# 2017 Corvette: GM TechLink: 3rd Gear Condition on Manual Transmission

## 3rd Gear Condition on Manual Transmission

**GM TechLink**

**November 23, 2016**

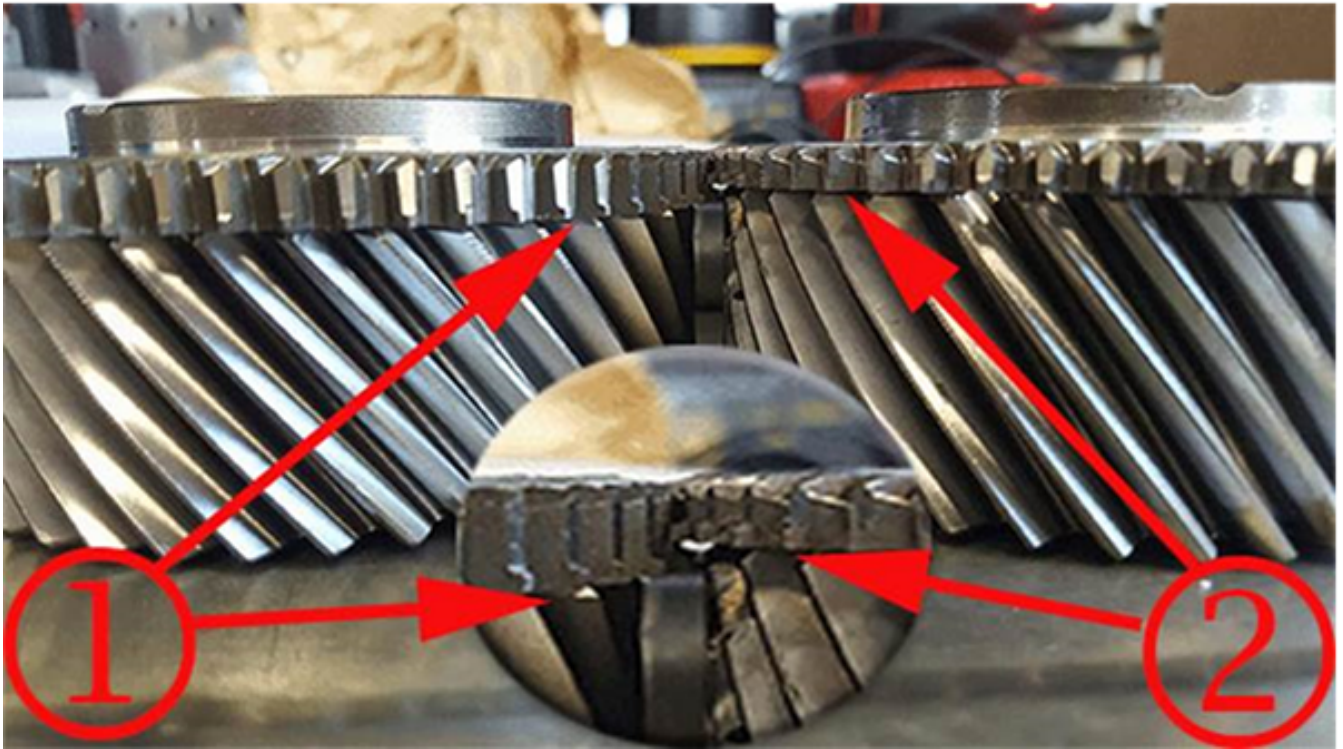
Some 2017 Camaro and ATS-V models equipped with a 6-speed transmission (RPO MM6, MG9) and 2017 Corvette models equipped with a 7-speed transmission (RPO MEP, MEK) may hop out of 3rd gear due to a mis-machined gear. These vehicles will have very low mileage or the condition may be noticed during PDI.

If the transmission does not hop out of 3rd gear, shift back to 2nd gear and repeat the shifting and accelerating procedure 10 times. If the transmission does not hop out of 3rd gear, the transmission has the correctly machined gear. (Fig. 14, #1) If the hop out of 3rd gear is verified, there is a mis-machined gear (Fig. 14, #2) and the 3rd speed gear, synchronizer and shift collar should be replaced.
